AURIX™ TC35x errata sheet

Marking/Step: (E)ES-AB, AB

10593AERRA

Figure 1 Message buffer transfer from Message RAM to OBF

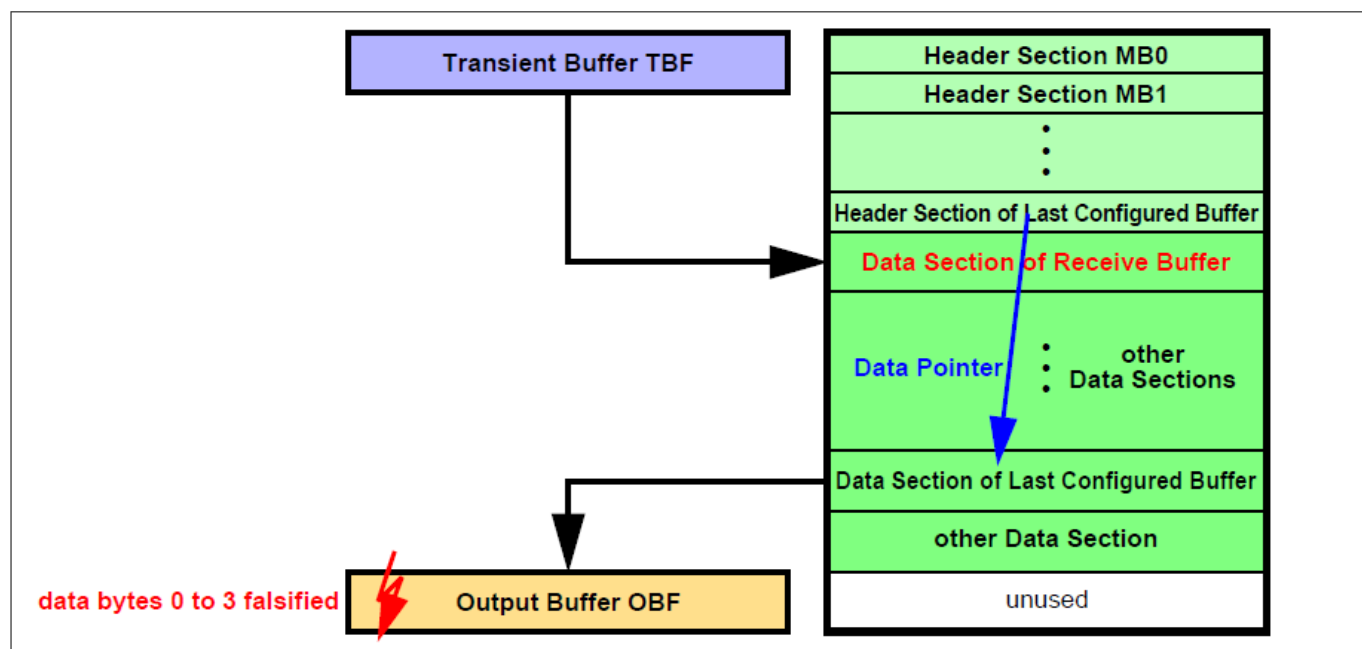
a) When a message is transferred from the Last Configured Buffer in the Message RAM to the OBF and PLC = 127 it may happen, that at the end of the transfer the OBF word on address 00h (payload data bytes 0 to 3) is overwritten with unexpected data (see [Figure 1](#))

Ensure that the Data Section directly following the Header Partition is assigned to a transmit buffer.

Figure 2 Message buffer transfer from IBF to Message RAM

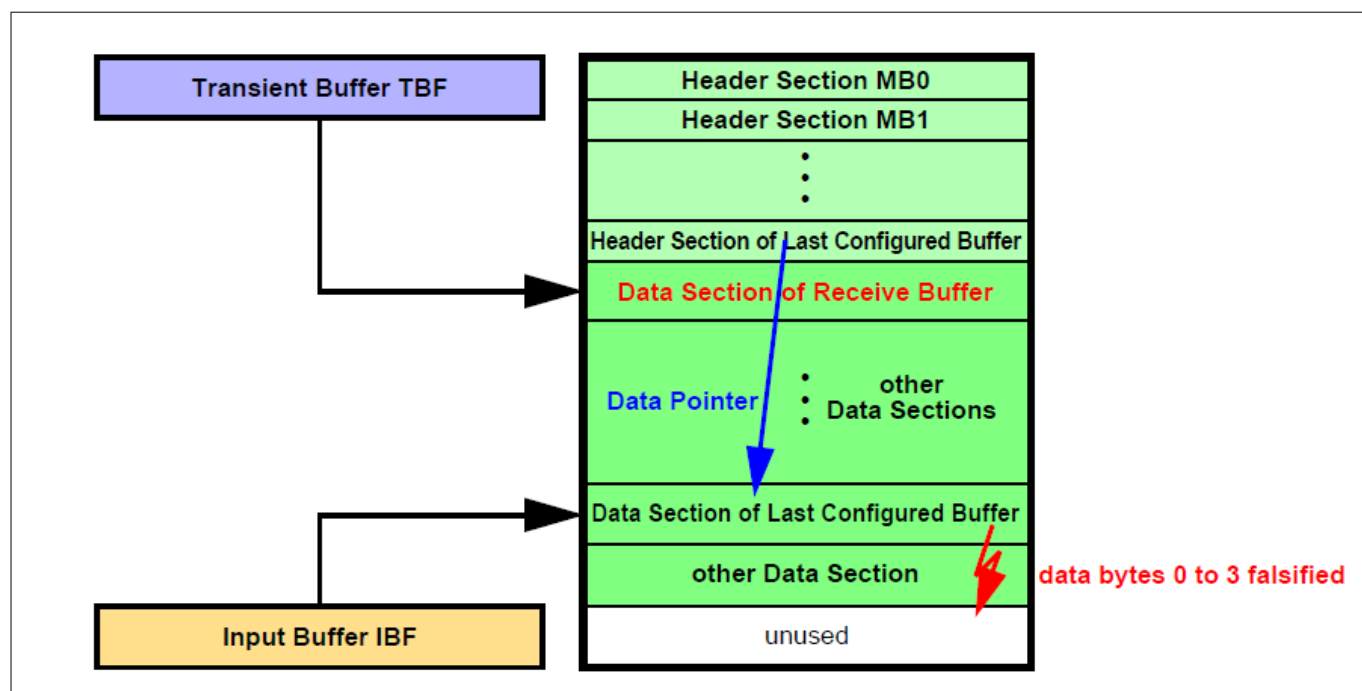
b) When a message is transferred from IBF to the Last Configured Buffer in the Message RAM, it may happen, that at the end of the transfer of the Data Section one additional write access overwrites the following word, which may be the first word of another message's Data Section in the Message RAM (see [Figure 2](#))

Figure 3 Message RAM configurations

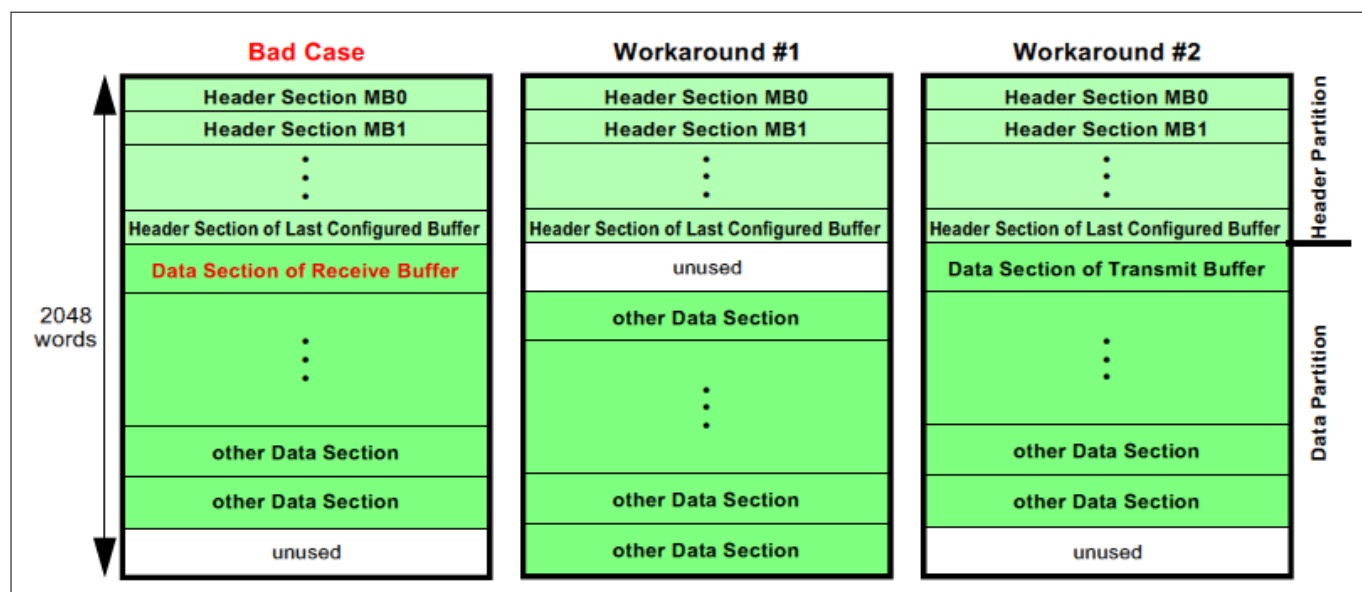
The erratum is limited to the case when (see [Figure 3](#) “Bad Case”):

Figure 5 CAN Frame with $DLC > 4$

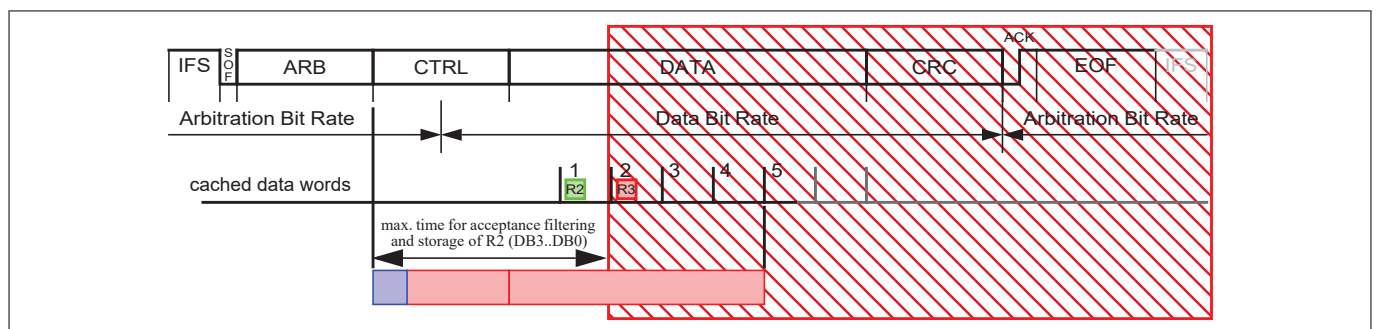
The figure that follows shows how the available time for acceptance filtering and storage is reduced.

Due to condition 3) the issue only occurs sporadically. Use an end-to-end (E2E) protection (for example, checksum or CRC covering the data field) and add it to all messages in the CAN system, to detect data corruption in received frames.

Figure 6 Positive overload on P-pad of a LVDS RX pin pair (both used as inputs)

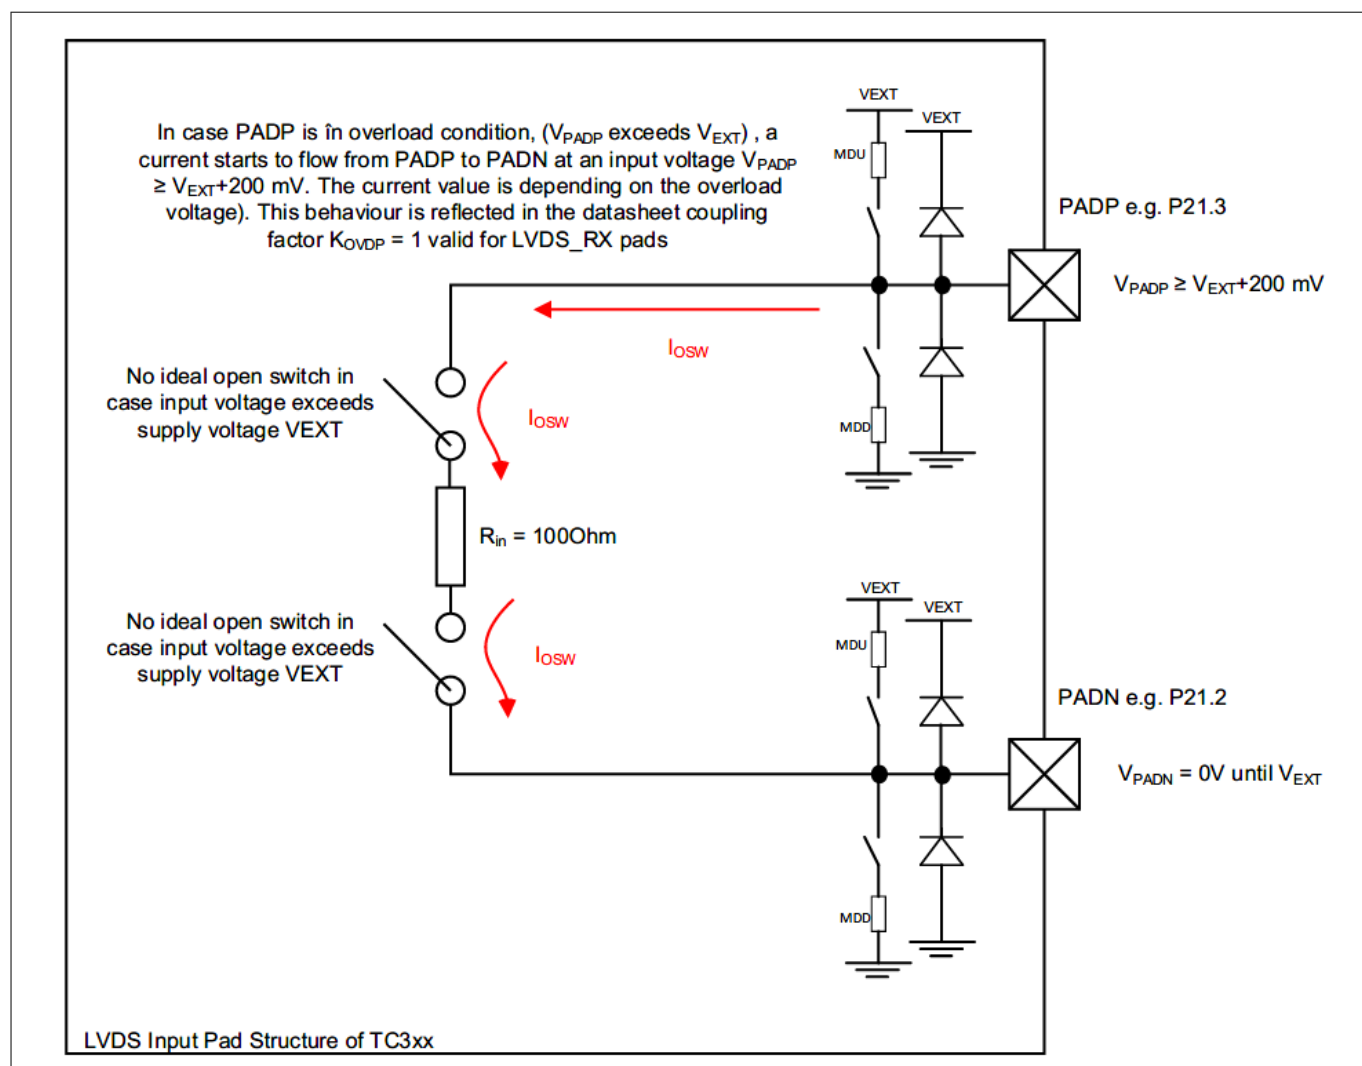
The overload current I_{OSW} through the non-ideal open switch significantly increases when $V_{PADP} \geq V_{EXT} + 200 \text{ mV}$.

Note: In general, the effect will also occur if the N-pad is used as output, or for a negative overload condition on either the P-pad or the N-pad.
